## Planning Commission Staff Report

January 13, 2016  
Item 6.b.

**SUBJECT:** Work Session for PUD-114

**PURPOSE:** Work Session to review and receive comments on a proposal to construct five detached single-family homes and related improvements on an approximately 4.3-acre portion of the 16-acre Pleasant View Church of Christ site

**Figure 3: Focused Site Plan**

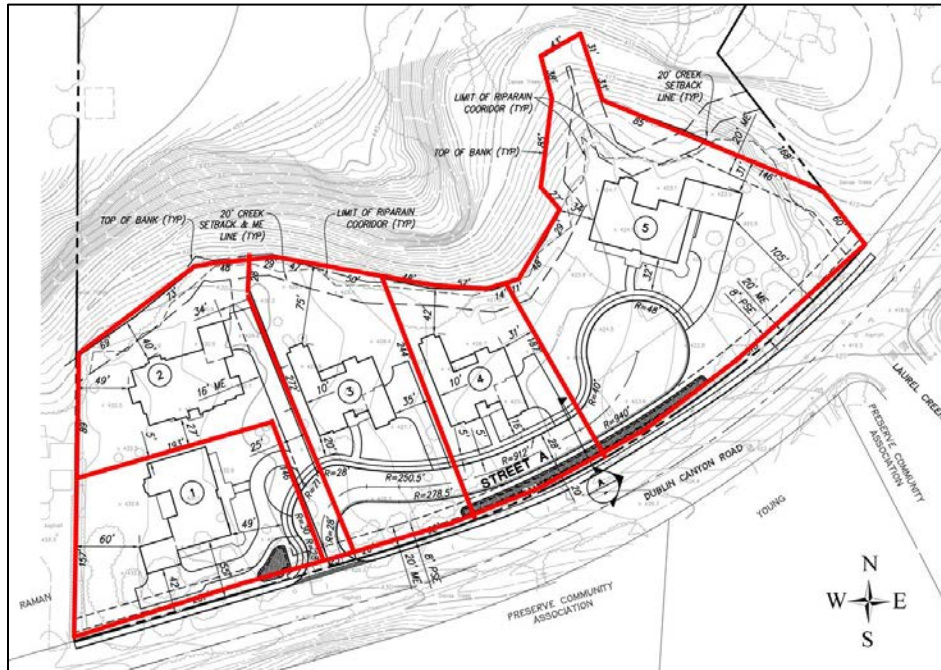
The proposed five lot subdivision is located just south of a creek. The location and path of the adjacent creek and creek setback has dictated where the homes can be located. Due to the alignment of the creek, the applicant has pushed Lots 3 and 4 closer to Dublin Canyon Road, requiring the proposed frontage street to curve as well. The Traffic Division, Engineering Division, and Fire Department have reviewed the proposed

turning radius of the street and have found it acceptable but not ideal. The street entry and curved design does not allow for easy entry into the project from Dublin Canyon Road which has a speed limit of 45 miles per hour.

In addition to access and circulation concerns, the unusual curve in the frontage road has reduced the width of the landscape area between the frontage road and Dublin Canyon Road to approximately 20 feet between the Dublin Canyon Road property line and the frontage road. Finally, staff does not believe that a frontage road adjacent to Dublin Canyon is appropriate for this location. Staff would like Planning Commission's comments regarding the proposed site plan, street design and landscape setbacks.

2. Are the overall site plan, lot locations and street design layout acceptable?

**Figure 6: Creek Setback**

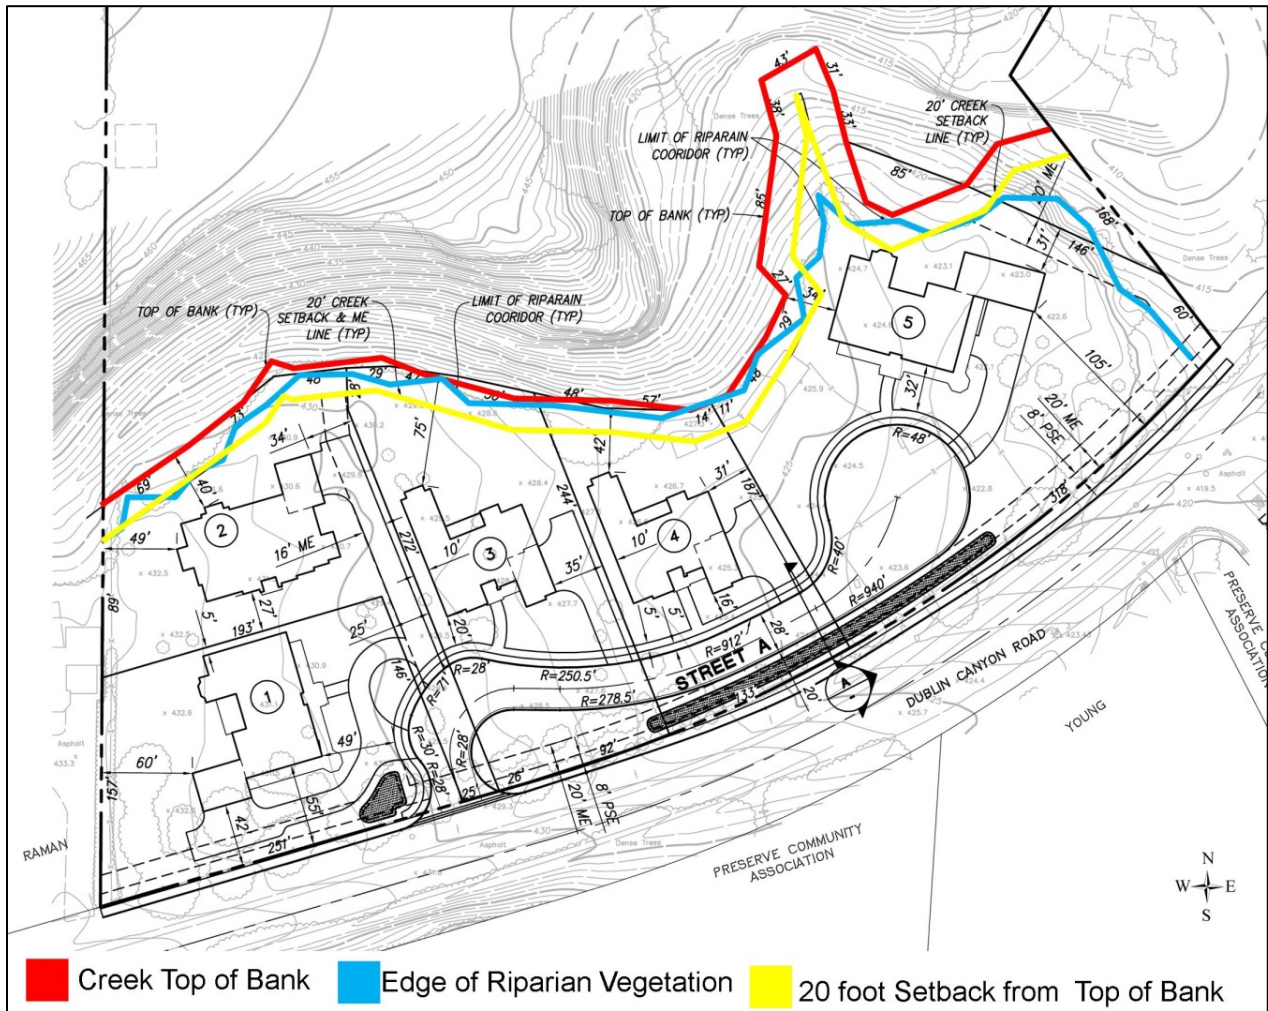
The 16-acre property is divided by a creek running west to east that divides the proposed homes from the church site. The project plans identify the top of the creek bank as well as the edge of riparian vegetation (see Figure 6). Although the project currently illustrates a 20-foot creek setback, measured from the top of bank, in which no structures or improvements are permitted, future plans will have to be revised to show that no new grading or development would occur within 20 feet of the edge of riparian vegetation or top of bank, whichever is further from the creek centerline. Although this will further limit the developable area of the site, a more expansive definition of creek setback is consistent with past practice in creek-side developments in Pleasanton.

**Figure 7: General Plan Designation**

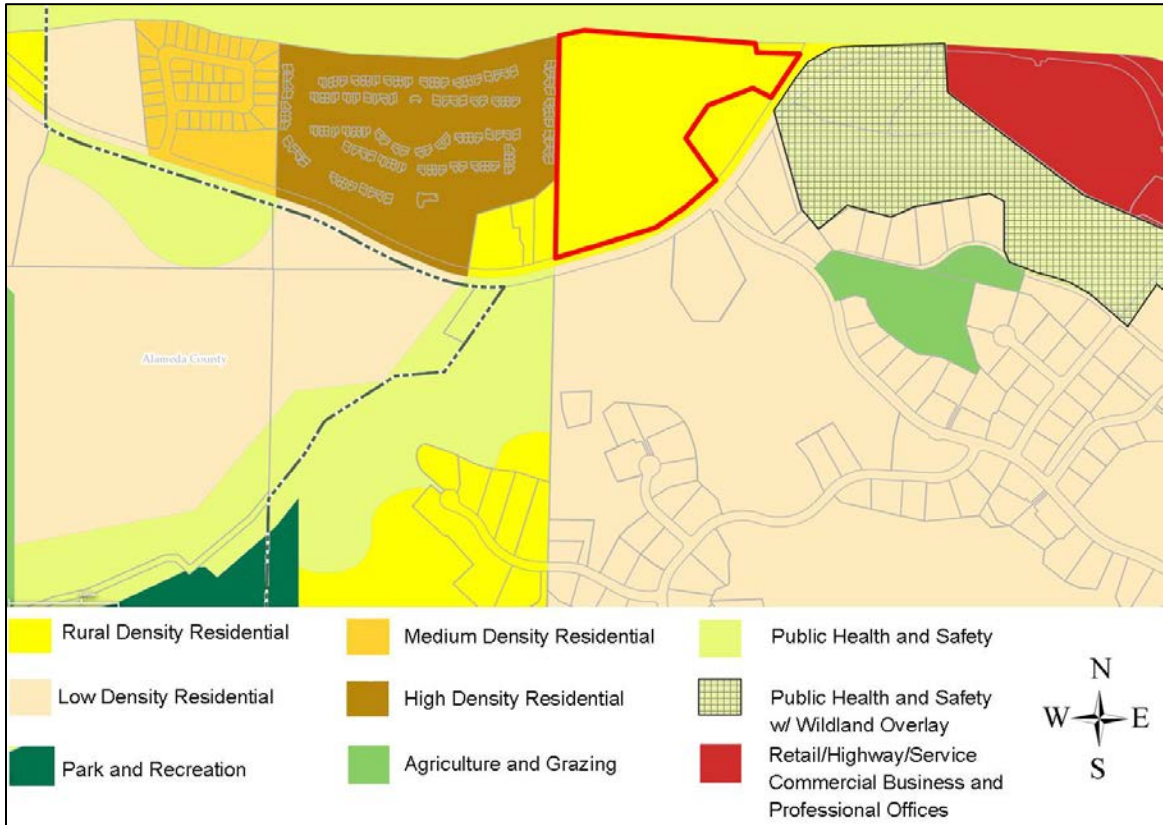
Both the General Plan and Zoning designations allow for one dwelling unit per 5 acres. If the entire 16.23-acre site is taken into consideration, the current designations would permit a total of three dwelling units. The applicant is requesting a General Plan amendment and Zoning Change to the PUD - Low Density Residential (PUD-LDR)

designation to allow for 1.2 units per acre on the proposed 4.3 acre portion of the site, allowing for a total of five dwelling units. Staff does not support the requested General Plan amendment or Zoning Change to PUD-LDR.

1. Does the Commission support a General Plan Land Use Amendment to increase the density of the subject parcel?
